Addendum 3 for RFB898201-03

Project Name: STS Decentralization Tunnel Abandonment Package
DAS RFB #: 898201-03
DAS Project #: 8982.01
Date: 01/22/2021

E2

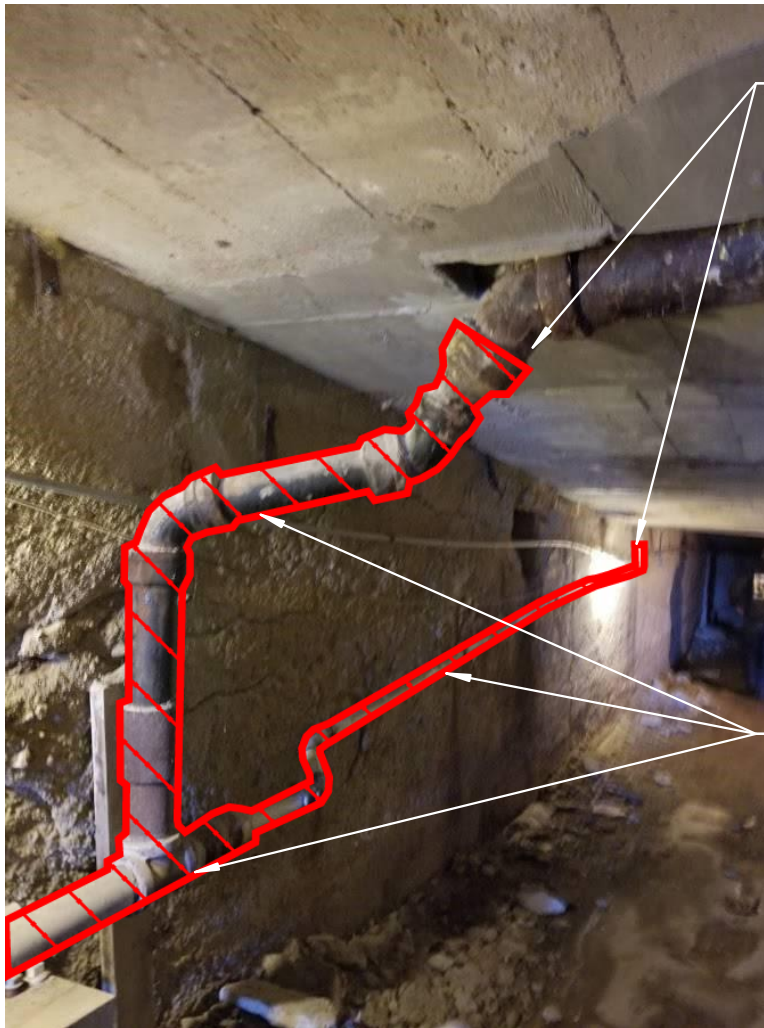
- A23. It is believed that the sewer line in the ash tunnel/fuel tunnel locate under and east of the Power Plant Building is still active. This line shall be replaced with new pipes and supports as required to support during grout installation. Refer to Sheet 00-S2.06 Detail E2 which is added as part of this addendum for more information.

4. Sheet 00-S2.06 – Add Detail E2 as shown on the attached supplemental drawing. This fuel tunnel/ash tunnel sewer work shall be included in BP #02-1 Alternate #2.
5. Sheet 12-E2.01 – Add keynote ETA-12-03 to read ""Add 100' of #4/0 bare copper conductor from the ground bar of MDP panel to a new 5/8" diameter 10' long copper clad steel ground rod to be placed outside of the building. Remove the ground wire that is connected to the water line in the tunnel"

ROUTE NEW 4" SANITARY LINE IN TUNNEL FROM UNDERGROUND CLEAN OUT TO REMAINING 6" SANITARY PIPE THROUGH TUNNEL ROOF AND RECONNECT. ROUTE 2" SANITARY LINE TO EXISTING 2" PIPE THROUGH TUNNEL ROOF AND RECONNECT.

REMOVE EXISTING ABOVE-GROUND 2" (APPROX. 25 FT) AND 4" (APPROX 60 FT.) HORIZONTAL SANITARY PIPE IN ASH TUNNEL. REMOVE PIPING UP TO TUNNEL ROOF. 2" AND 6" SANITARY PIPES GOING THROUGH TUNNEL ROOF TO REMAIN FOR CONNECTION TO NEW LINE.

FUEL TUNNEL SEWER TO REMAIN
